Access Compliance Report

Public Rights-of-Way

(Curb Ramps)

Intersection ID: 47981	Main Street: SPRINGS_MILL_RD	Cross Street: WHEAT_RIDGE_RD	Location: NE
ADA ID: 7B9CCABA44BF	Ramp Type: PerpDiag	Initial Pass/Fail: Fail	Overall Compliance: No
Severity Score: 13.75			
Codes/Mitigation Info/Possible Solution		Field Measurements/Component Compliance

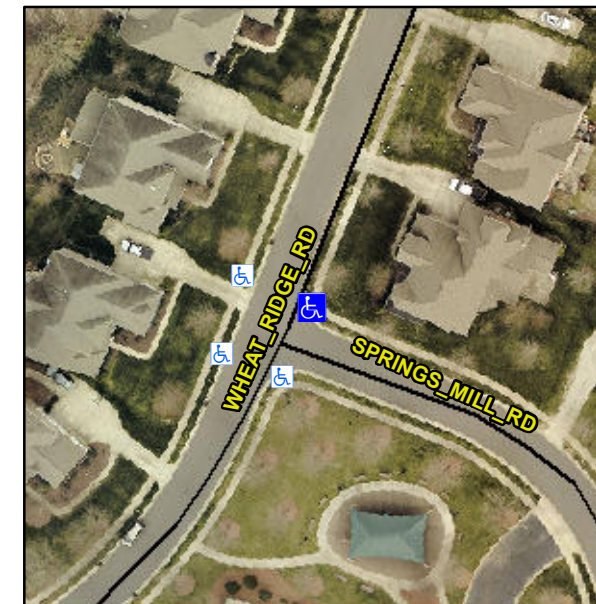
Not Found, R304.2.2, R304.5.3

Compliance	Description	Data	Compliance	Description	Data
N/A	Ramp Length (in)	51.0	No	Ramp Slope (%)	8.5
Yes	Ramp Width (in)	48.0	No	Ramp XSlope (%)	4.0
N/A	Flare Type LT	N/A	N/A	Flare Type RT	N/A
N/A	Flare Slope LT (%)	N/A	N/A	Flare Slope RT (%)	N/A
N/A	Flare Traversable LT?	N/A	N/A	Flare Traversable RT?	N/A
N/A	Landing Length (in)	N/A	N/A	DWS Provided?	N/A
N/A	Landing Width (in)	N/A	N/A	DWS Contrast?	N/A
N/A	Landing Slope (%)	N/A	N/A	DWS Length (in)	N/A
N/A	Landing X Slope (%)	N/A	N/A	DWS Full Width?	N/A
N/A	Landing Curb? (Y/N)	N/A	N/A	DWS Offset (in)	N/A
N/A	Shared Landing?	N/A			
N/A	Gutter Ponding?	N/A	N/A	Gutter Slope (%)	N/A
N/A	Gutter Lip Ht (in)	N/A	N/A	Gutter X Slope (%)	N/A
N/A	Painted X Walk1?	No	N/A	Painted X Walk2?	No
	X Walk 1 Direction	To NW		X Walk 2 Direction	To SW
N/A	X Walk 1 Width (in)	N/A	N/A	X Walk 2 Width (in)	N/A
	X Walk 1 Slope (%)	4.7		X Walk 2 Slope (%)	1.4
	X Walk 1 X Slope (%)	0.8		X Walk 2 X Slope (%)	2.4

Remove & Replace Curb Ramp With Two New Directional Ramps or Equivalent.
